# Discussion of Comment R1-2 in p802.3cx

Alon Regev, Keysight Technologies

Nov 28, 2022

# Example: 100BASE-T1 PAM3

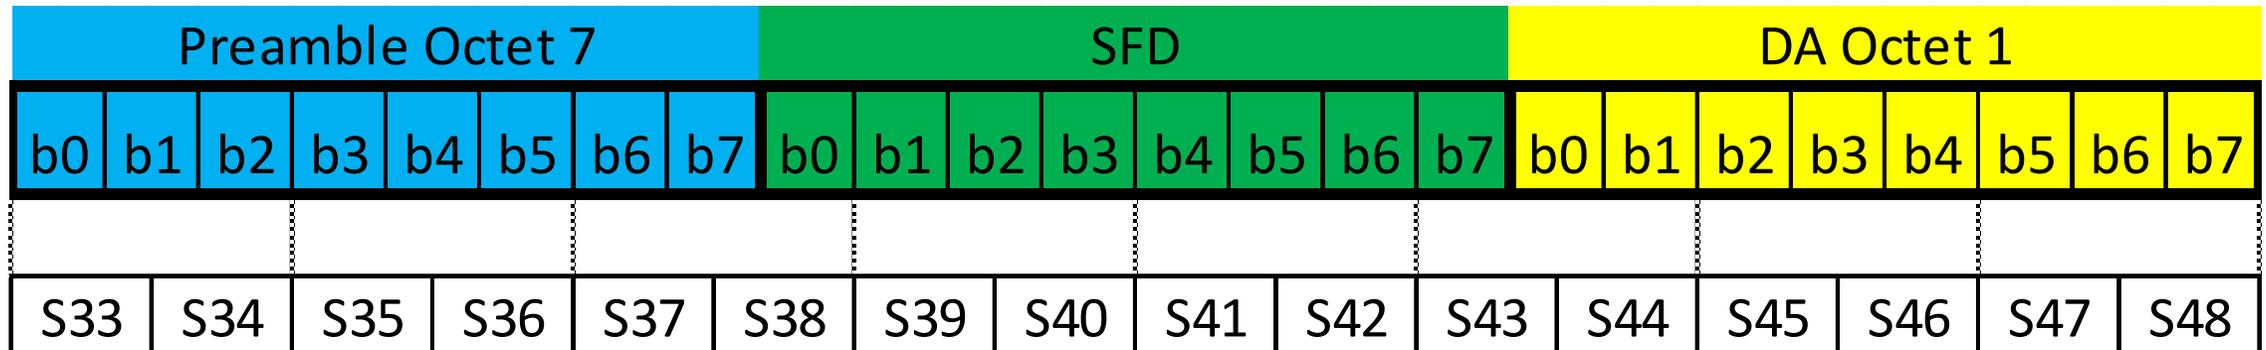
Current text is ambiguous as to which symbols to use

- Potential symbols for SFD
  - S37 – first symbol of 2-symbol set that contains the first bit of the SFD
  - S38 – second symbol of 2-symbol set that contains the first bit of the SFD
  - S39 – first symbol that contains only SFD bits
- Potential “first symbol after the SFD”
  - S43 – first symbol of 2-symbol set containing the first bit of DA
  - S44 – second symbol of 2-symbol set containing the first bit of the DA
  - S45 – first symbol not containing any part of the SFD

Figure 36-3—PCS reference diagram

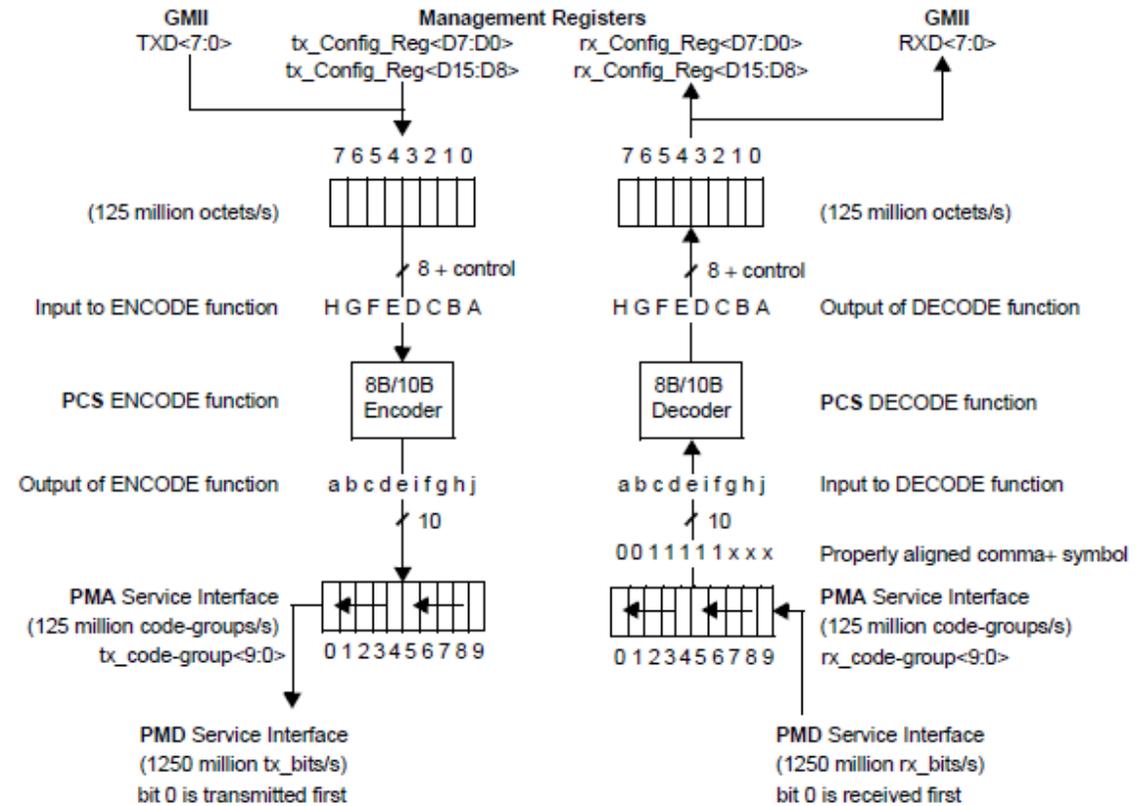
- This is a case of a PCS sublayer with a delay that is constant
- 8-bits at GMII are transformed “instantly” to/from a 10-bit code-group
- For path data delay measurement, “beginning of DDMP” corresponds to bit  $\langle 7 \rangle$  at GMII and to bit  $a$  at MDI

# Consideration for 64B/66B

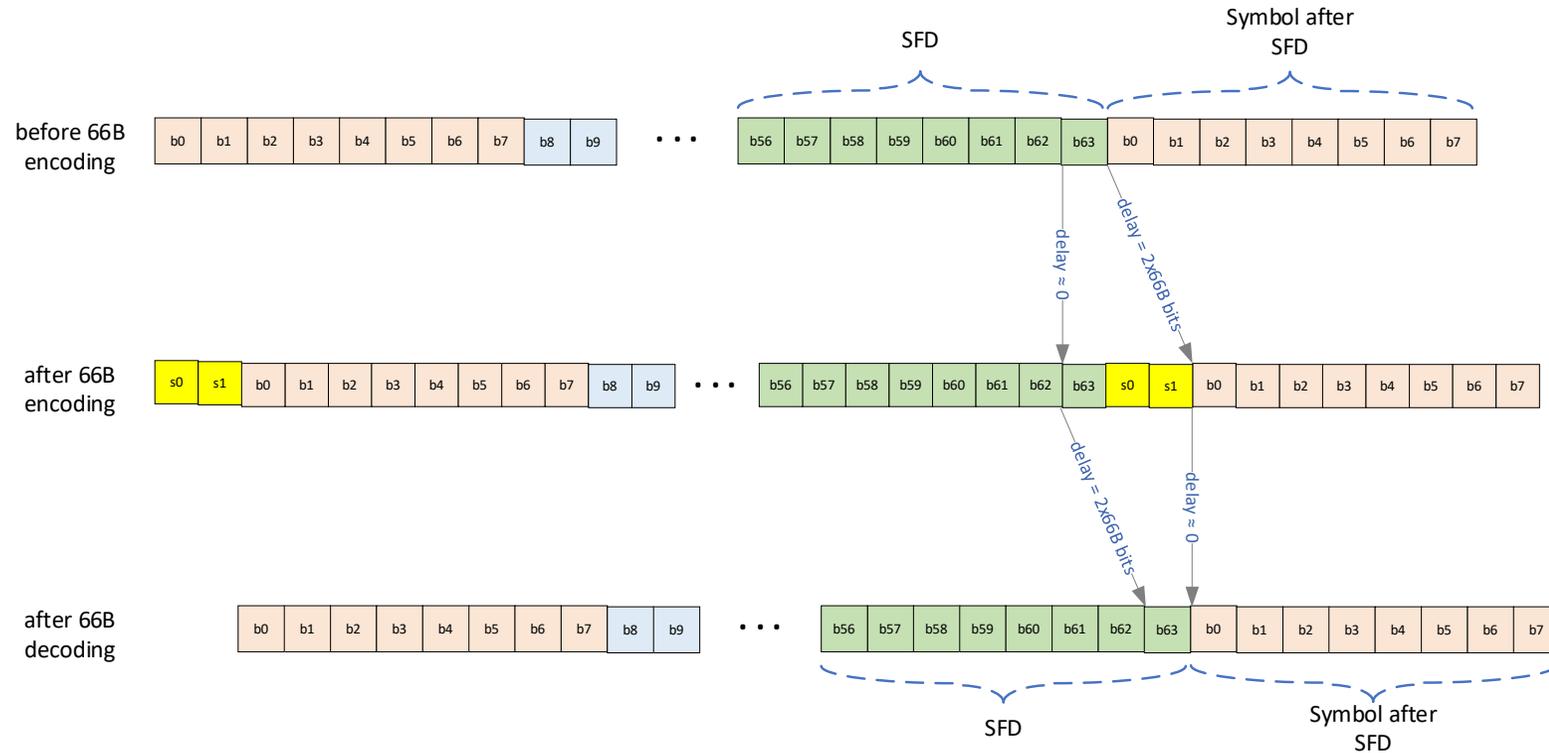
- Insertion of 66B sync bits is like insertion of FEC overhead
  - bit b0, placed immediately after the sync bits, experiences the most Tx path data delay
  - bit b63, placed immediately before the sync bits, experiences the least Tx path data delay
  - Tx path data delay and Rx path data delay are mirrors of each other, resulting in equal delay across encoder + decoder for all bits
- Using the same method as FEC (i.e., allocate max delay to Tx and min delay to Rx), we allocate  $2 \times 66B$  bit delay to the Tx encoder and 0 to the Rx decoder
  - This insinuates that a data bit, not a sync bit, is timestamped at the MDI
  - However, because 802.3 timestamps DDMP at the xMII and models the PHY delays as constants, the definition of the DDMP at the MDI is not important
